Ordinance 2021-03 – Possible Approval on First Reading and Setting a Public Hearing Regarding the Holman Court Planned Development and Major Subdivision.

UPDATE TO PLANNED DEVELOPMENT AND SUBDIVISION PROPOSALS:

HOLMAN COURT LANNED DEVELOPMENT (PD) SALIDA, COLORADO

AMENDED CONDITIONS OF APPROVAL FOR HOLMAN COURT PD:

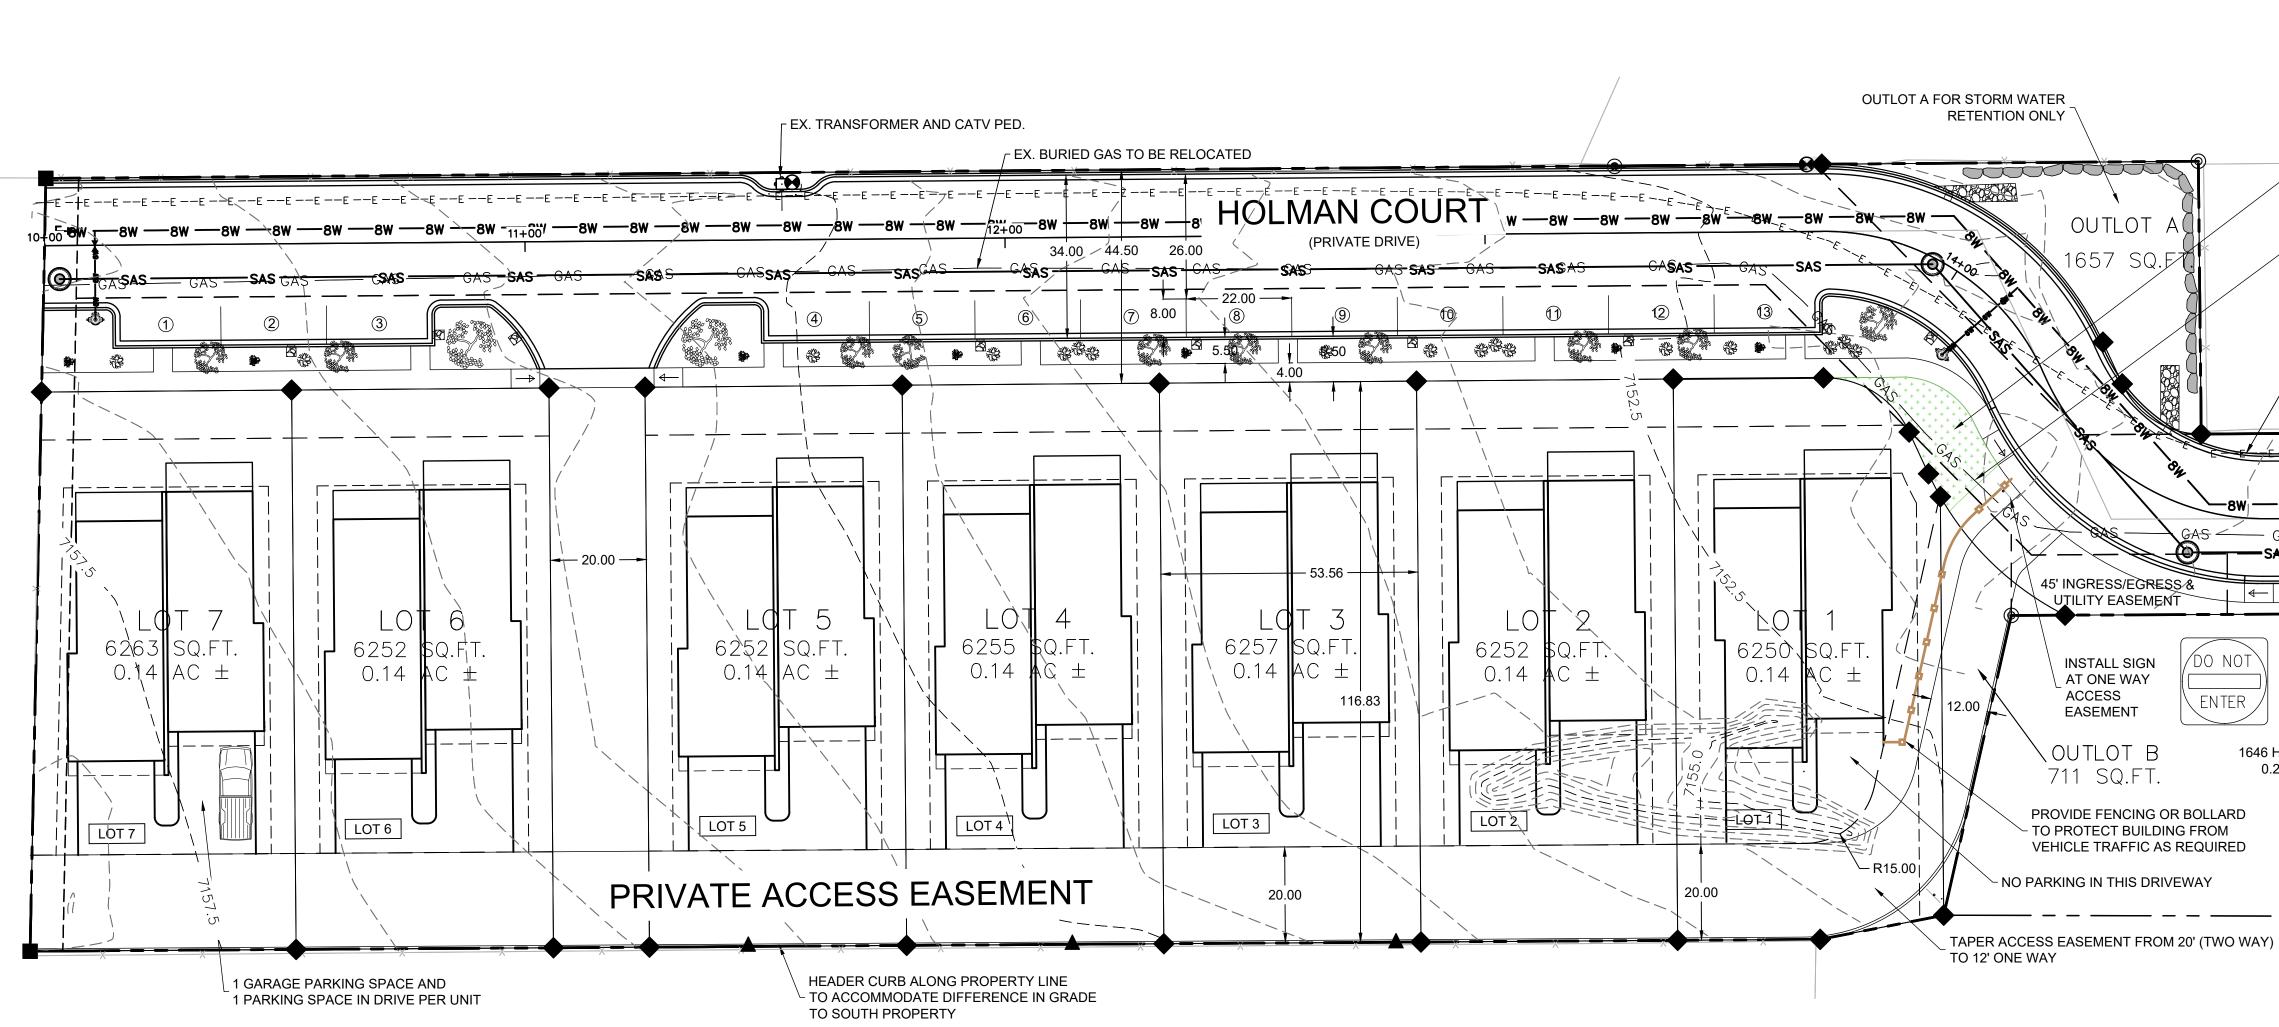
OCCUPANTS OF ANY DEED-RESTRICTED AFFORDABLE UNITS WITHIN THE HOMEOWNERS ASSOCIATION SHALL NOT BE RESPONSIBLE FOR ANY ASSESSMENTS NOR DUES BEYOND THOSE FAIRLY-PRICED SPECIFICALLY FOR UTILITIES, TRASH SERVICES, AND THE LIKE. 2. EACH LOT SHALL HAVE AT MINIMUM ONE TREE LOCATED BETWEEN THE PRIVATE DRIVE AND THE FRONT OF THE PROPOSED UNITS. IN ADDITION, THE APPLICANT WILL PROVIDE AS MANY TREES WITHIN THE COMMON OPEN SPACES AS WILL RESULT IN A TOTAL OF AT LEAST 16

THE APPLICANT SHALL ERECT A VISIBLE BARRIER/FENCE, WITH ENTRY POINT(S), AROUND THE PERIMETER OF THE COMMON OPEN SPACE AREA AND PROVIDE REASONABLE FACILITIES SUCH AS PICNIC TABLES, BENCHES, CHILDREN'S PLAYGROUND EQUIPMENT, ETC., TO ENCOURAGE
